Attachment I

Response-to-Comments Table

Application for Permission Under Section 16 of the Town Planning Ordinance (Cap. 131) for Proposed Comprehensive Development including Flats, Retail and Community Facilities and Minor Relaxation of Plot Ratio and Building Height Restriction in "Comprehensive Development Area" Zone at Various Lots in S.D.4 and Adjoining Government Land, Kau Wa Keng, Kwai Chung

Figure 1

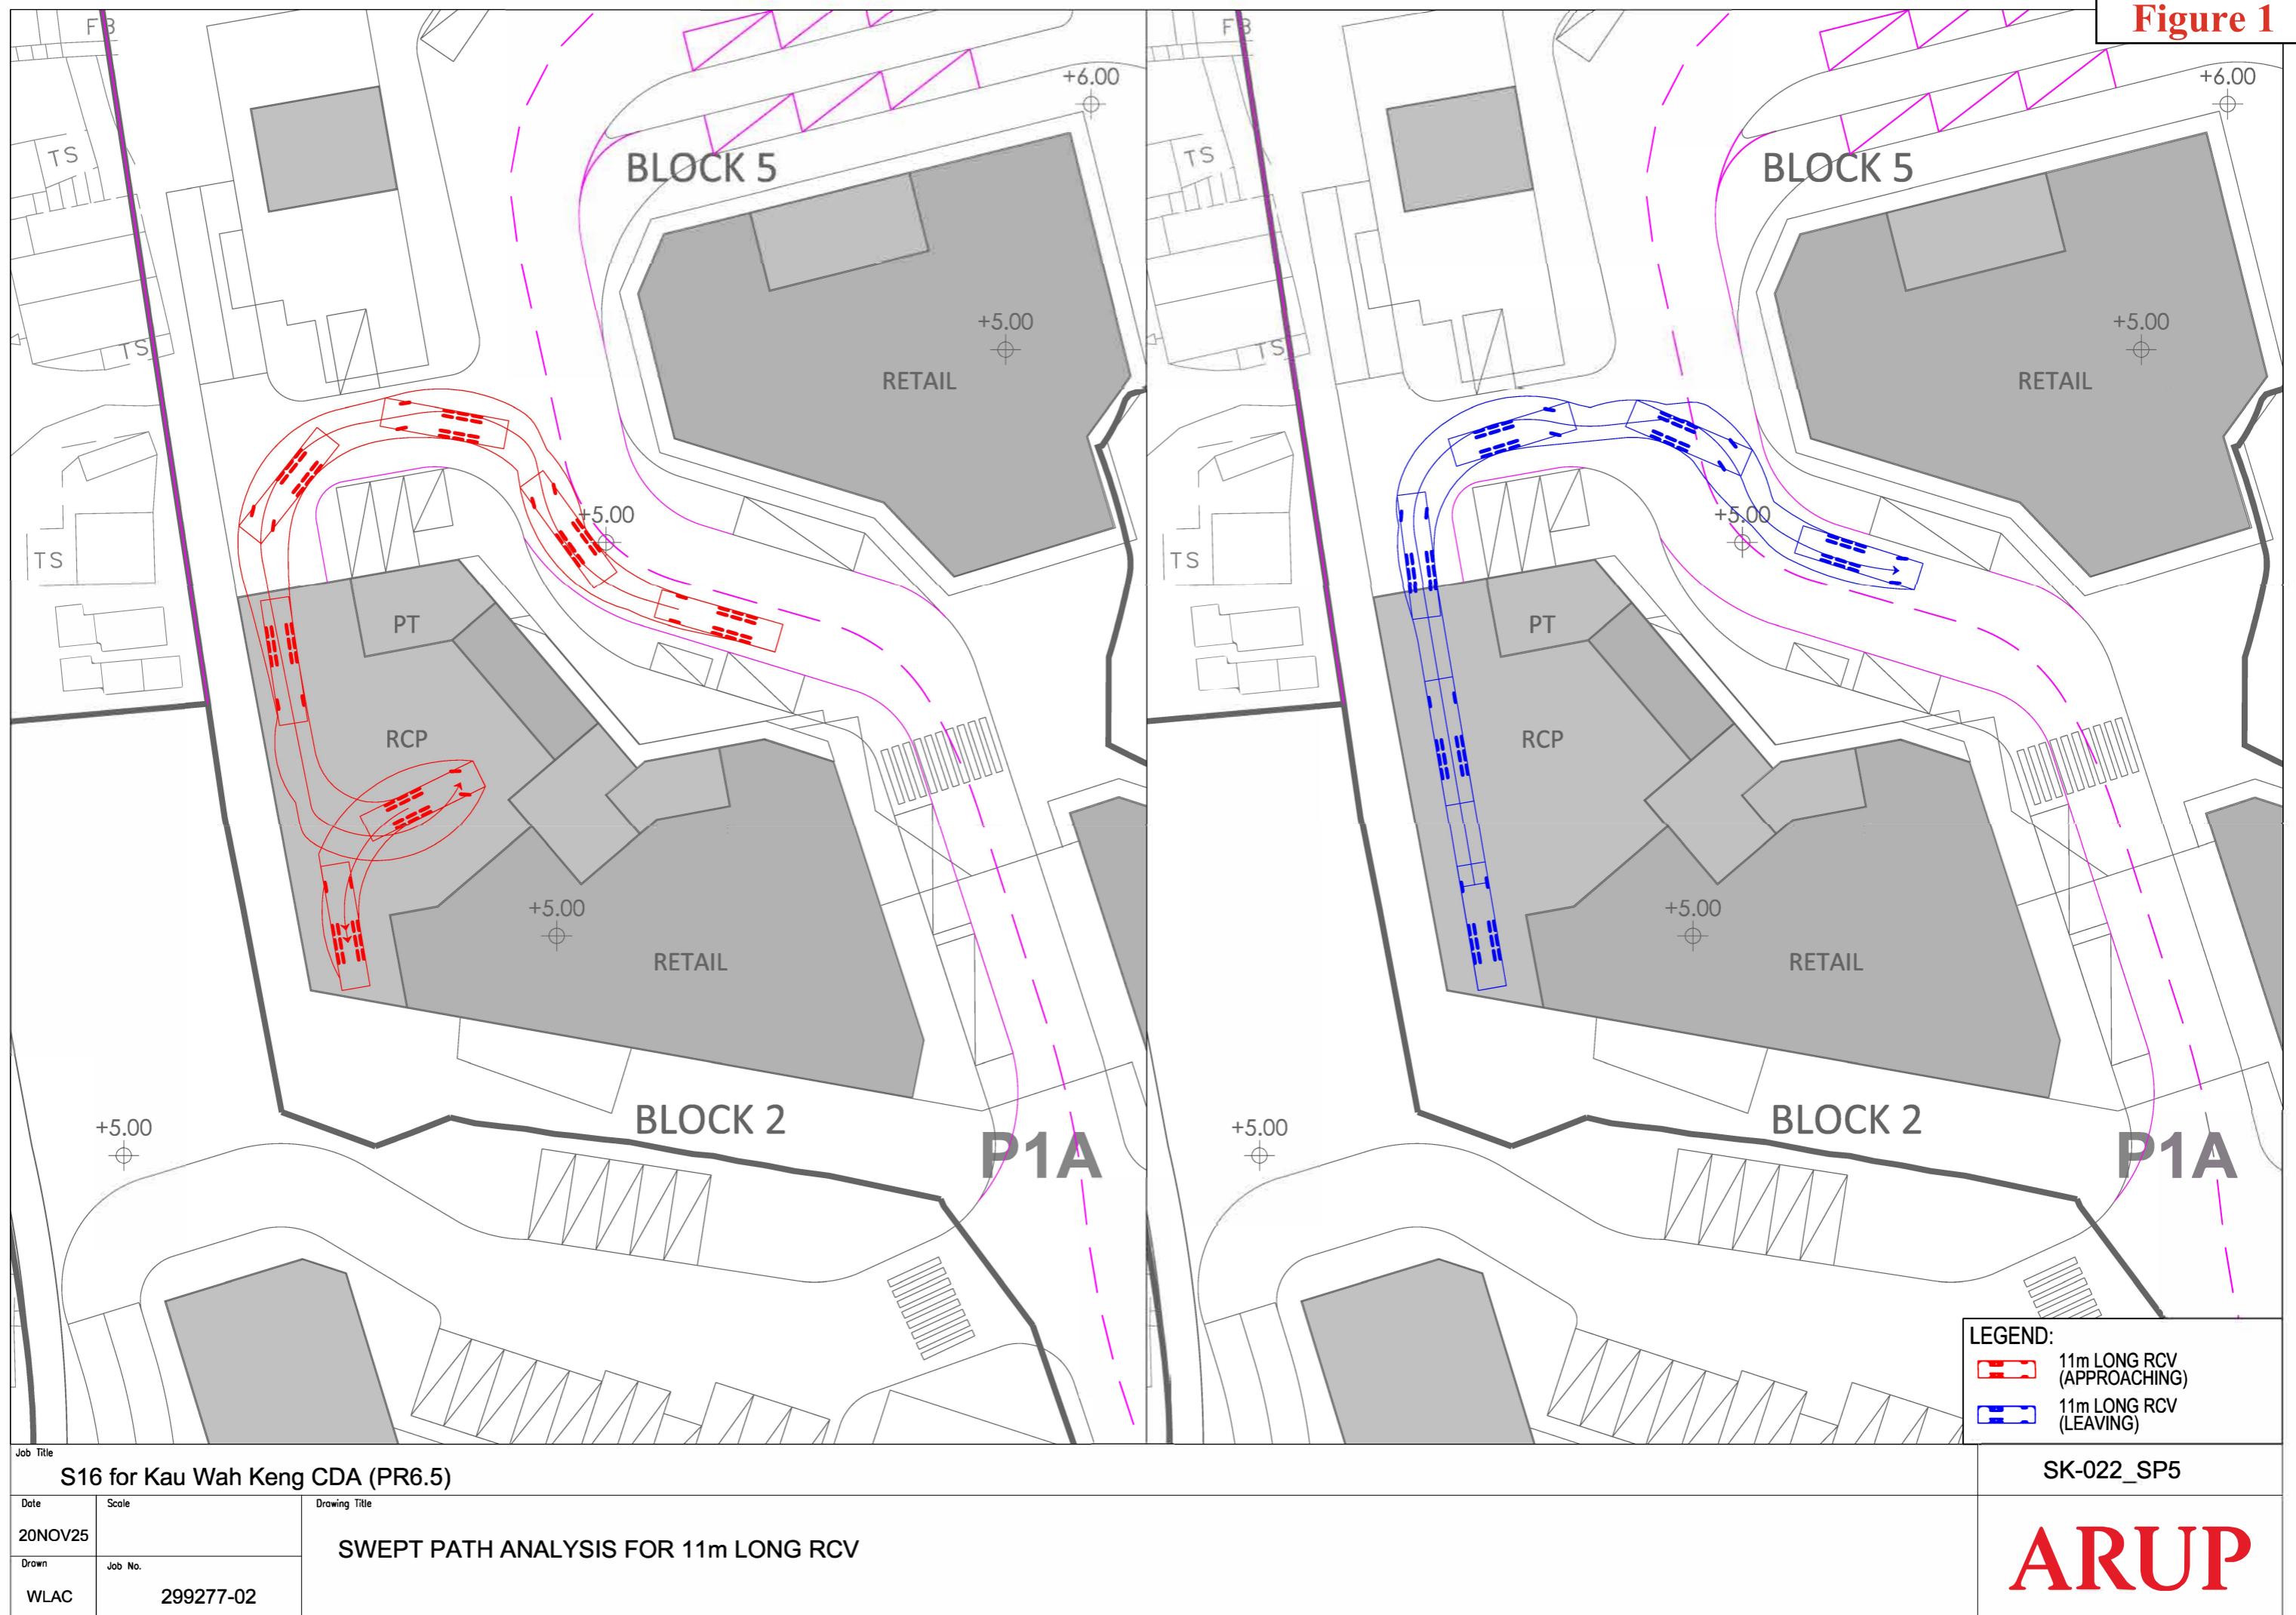
No.	Comments	Responses
	<p>Please note that all comments we provided previously would be superseded by the following comments:</p> <ol style="list-style-type: none"> <li data-bbox="314 467 890 673">1. The aqua privy at Kwai Tsing is situated at RPB (refer to attached layout plan). Reprovisioning of a new water flushing public toilet (PT) to public by the project proponent up to the satisfaction of FEHD may be required. <li data-bbox="314 696 890 1336">2. The temporary Kau Wah Keng Refuse Collection Point (RCP) is situated between RPA and P1A. This RCP is mainly providing the refuse collection service in the vicinity of Kau Wah Keng old/new village. Reprovisioning of a permanent RCP, with parking area for refuse collection vehicles (RCV), provision of sufficient space for RCV maneuvering and turning, loading bay/refuse storage area, vehicular entrance, secondary entrance for handcarts, office-cum-roll call point, storeroom and storage area for handcarts and refuse bins, staff toilets and changing rooms as stipulated in FEHD's Handbook on Standard Features for Refuse Collection Points, is required. Additionally, the new permanent RCP and PT should be constructed together in one location for better operational efficiency. <li data-bbox="314 1358 890 1695">3. As Kau Wah Keng RCP is the only RCP providing refuse collection service in the vicinity of Lai King Hill Road, the current temporary RCP should either be retained or, if demolished, replaced with a new temporary RCP until the permanent RCP is completed and ready for operation to ensure uninterrupted daily refuse collection services throughout the whole construction period. <li data-bbox="314 1718 890 1987">4. RCP should be accessible from the main road and capable of accommodating all waste collection vehicles (WCVs) (e.g., 24-tonne grab lorry, 30-tonne compaction WCV, 30-tonne hook-lift truck) with sufficient maneuvering and loading space. Please provide <u>a swept path analysis</u> for confirming the accessibility of the RCVs. 	<p>Please note that the new water flushing public toilet is now relocated to Phase 1A in the updated MLP (Appendix B).</p> <p>Please note that the proposed permanent RCP has been relocated to Phase 1A in the updated MLP (Appendix B). It will comply with the requirements stipulated in FEHD's Handbook on Standard Features for Refuse Collection Points. The new water flushing public toilet is also relocated to Phase 1A, adjacent to the proposed permanent RCP for better operational efficiency. The Applicant will consult FEHD on the detailed design of the RCP during detail design stage.</p> <p>Noted. We intend to induce minimal impact to the operation of existing temporary RCP until the permanent RCP in P1A is completed and ready for operation. Liaison with FEHD on temporary arrangement will be made during detailed design stage.</p> <p>A swept path analysis for an 11-m long refuse collection vehicle is provided in Figure 1 of this RtoC to demonstrate that the proposed permanent RCP has sufficient space for RCV maneuvering and turning.</p>
